Re: Turkey Point Units 3 and 4
Docket Nos. 50-250 and 50-251
Request for Additional Information Regarding
Station Blackout Analysis (TAC Nos. MB8728 and MB8729)

Response to Request for Additional Information Turkey Point Units 3 and 4 Station Blackout Coping Analysis

FIGURE 1. RCS VOIDED VOLUME

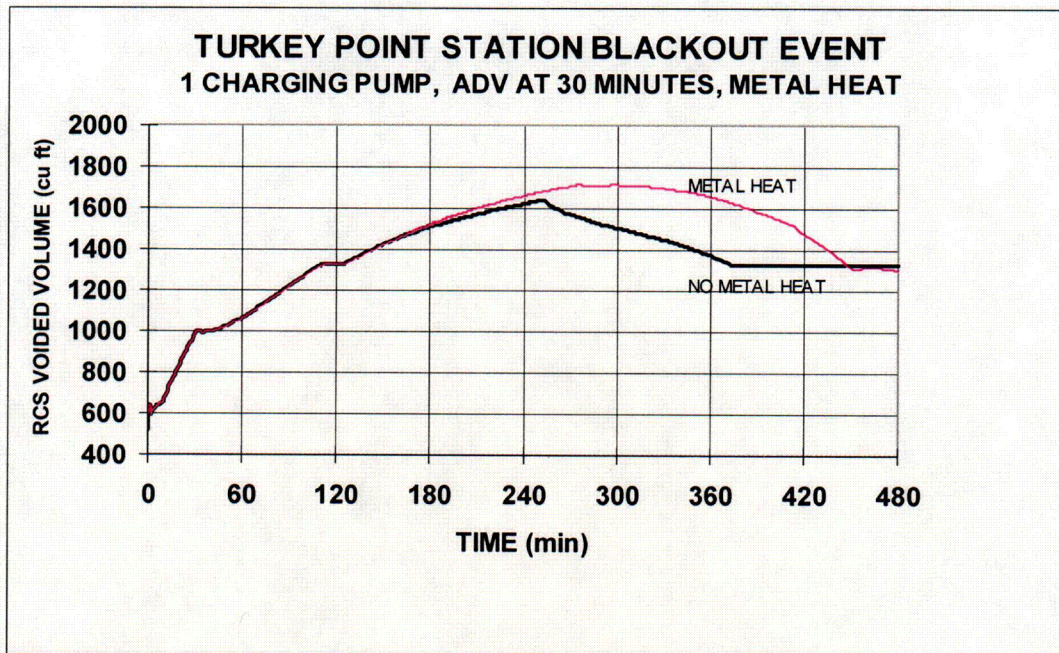
- 1. Perform a hand calculation to take into account metal wall heating effects for the first thirty minutes of the event prior to starting the charging pump. The purpose of the hand calculation is to show that there is no voiding at the U-bends in the steam generators.***

The original RETRAN analysis, (PTN-BFSF-02-142) discussed in FPL letter L-2003-286, has been rerun with the metal heat in the reactor vessel upper head included to assess its impact on RCS voiding. Specifically, the new analysis is intended to evaluate the impact that the vessel head metal stored energy has on the dynamics of the upper head bubble and whether or not the top steam generator tubes would void thus interrupting RCS natural circulation cooling. In addition to upper vessel metal heat, the new analysis also includes the modeling of the upper vessel region as a separated non-equilibrium region with two regions (vapor and two-phase mixture) allowed to be at different temperatures. That is, superheating of the vapor region is allowed. For conservatism, minimum inter-region heat transfer has been assumed. The results of the reanalysis are summarized below.

The additional heat load in the vessel upper head results in more voids being formed in that region. As Figure 1 shows, it also takes longer for these voids to start collapsing when metal heat is included. The upper head bubble is not entirely collapsed until around 7.5 hours with metal heat included versus around 6.25 hours without metal heat. However, the bigger upper head bubble generated with metal heat slightly increases the RCS pressure (Figure 2) and the amount of subcooling. Figures 3 and 4 confirm that subcooling is maintained throughout the event and that its magnitude increases when metal heat is included. Figure 5 shows that a substantial amount of liquid mass is always maintained above the top of the hot legs. Similarly, Figure 6 shows the response of the upper vessel liquid level with respect to the top of the hot legs and top of the core.
